Work Order ID 119540

Item Name: Fwd Crosstube - High

D212-664-141	Rev D (DEO)
--------------	-------------

DRAWING NO. D212-664-141	TITLE XTUBE ASSY (205/212/412 HI FWD)	REV. D	DART AEROSPACE LTD ENGINEERING ORDER		D.E.O. NO. D212-664-141-D-1	SHEET NO. SHEET 1 OF 2	SCALE NTS
DRAWN	CHECKED	MP	MFG. APPR.	ER	APPROVED	MP	DE APPR.
DATE 11.04.07	DATE 11.04.11		DATE 11.04.12		DATE 11/04/12		DATE 11.04.12

**D212-664-141/141B
ASSEMBLY DETAIL**

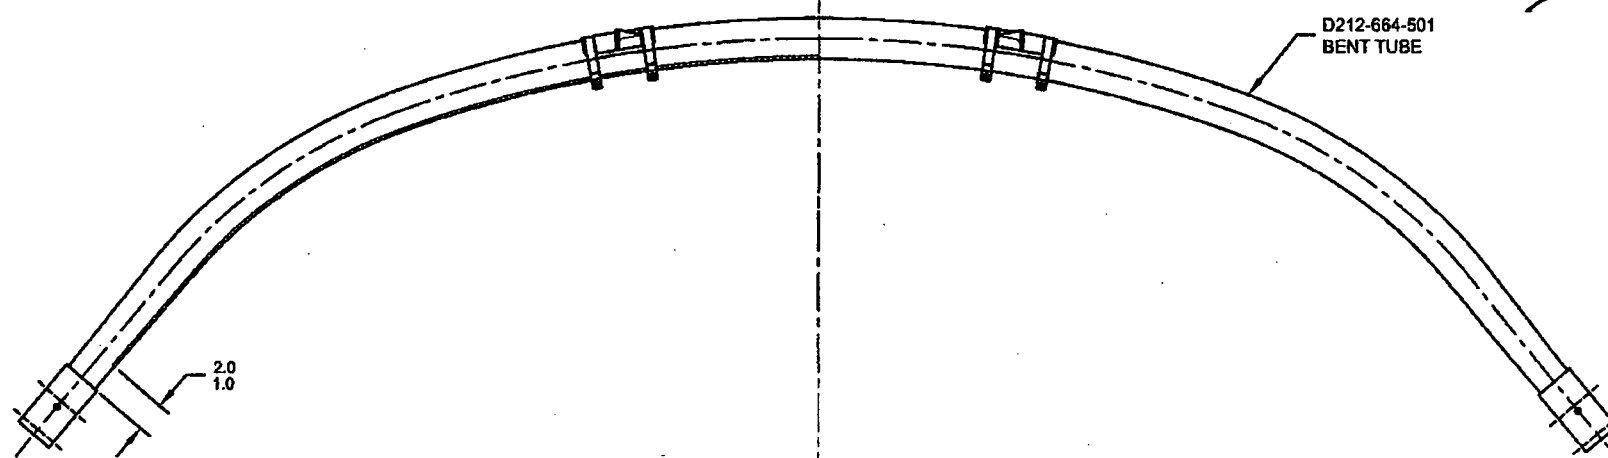
ADD AN INSPECTION WINDOW TO UNDERSIDE OF CROSSTUBE.

NOTES 2 OF SHEET 1 IS AMENDED AS FOLLOWS:

- 2) FINISH: CHEMICAL CONVERSION COAT PER DART QSI 005 4.1
PRIME INSIDE AND OUTSIDE PER DART QSI 005 4.2
MASK UNDERSIDE OF CROSSTUBE AS SHOWN (HATCHED AREA) AND
PAINT OUTSIDE PER DART QSI 005 4.2
REMOVE MASKING AND APPLY CLEAR COAT

IS:

WAS:

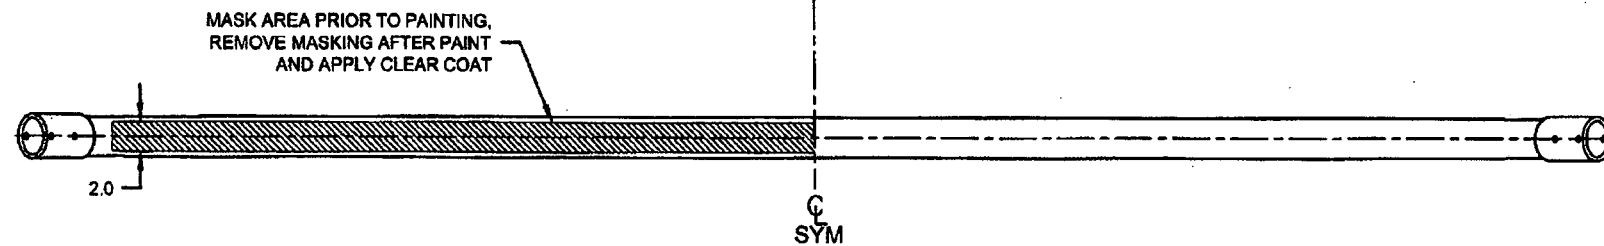
REPLACE MAGNOBOND WITH PROSEAL.

NOTE 12 & 15, SHEET 1 IS AMENDED AS FOLLOWS:

- 12) TO INSTALL D2893-1 SUPPORT: ABRASE MATING SURFACE OF SUPPORT AND CROSSTUBE WITH 180-GRIT SANDPAPER AND REMOVE RESIDUE WITH MEK (OR EQUIVALENT). APPLY A 0.04" TO 0.07" THICK LAYER OF PROSEAL 890 CLASS B-2 (OR AMS-S-8802 CLASS B-2) SEALANT TO MATING SURFACE OF SUPPORT.
- 15) TORQUE CLAMPS 80 TO 100 IN-LB. ENSURE AT LEAST 1.5 THREADS SHOWING IN SAFETY AND THAT NUT HAS NOT BOTTOMED-OUT AFTER TORQUING. **PRIOR TO PACKAGING, RE-CHECK TORQUE ON CLAMPS AFTER PROSEAL 890 SEALANT HAS CURED FOR 72 HOURS.**
